Stator (P/N F616095)

85 HP Force Outboard (1986 and prior models)

No spark on No. 3 cylinder after installation of replacement stator (Part Number F616095).

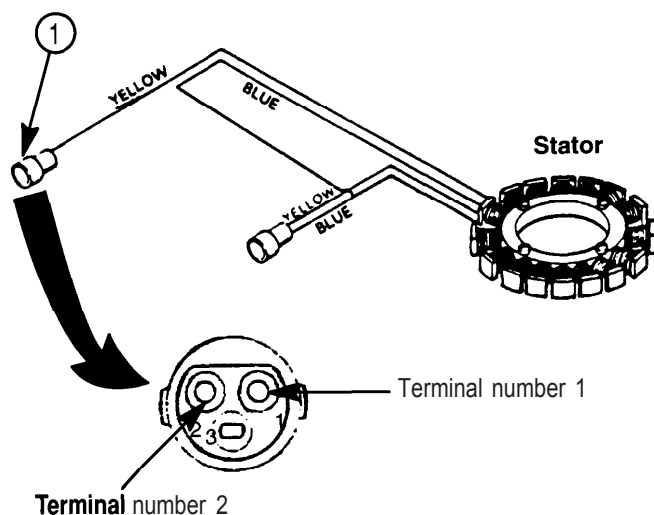
Inspect the wire and pin at the back of the plug (1) on the connector from stator. The yellow wire should be connected to the pin at terminal number 2 of plug (1). The terminals are marked. If the wire goes to the pin at terminal number 1, stator must be replaced.

If there are any F616095 stators in your inventory, please inspect them. If any are found to be defective, contact your distribution center for exchanges.
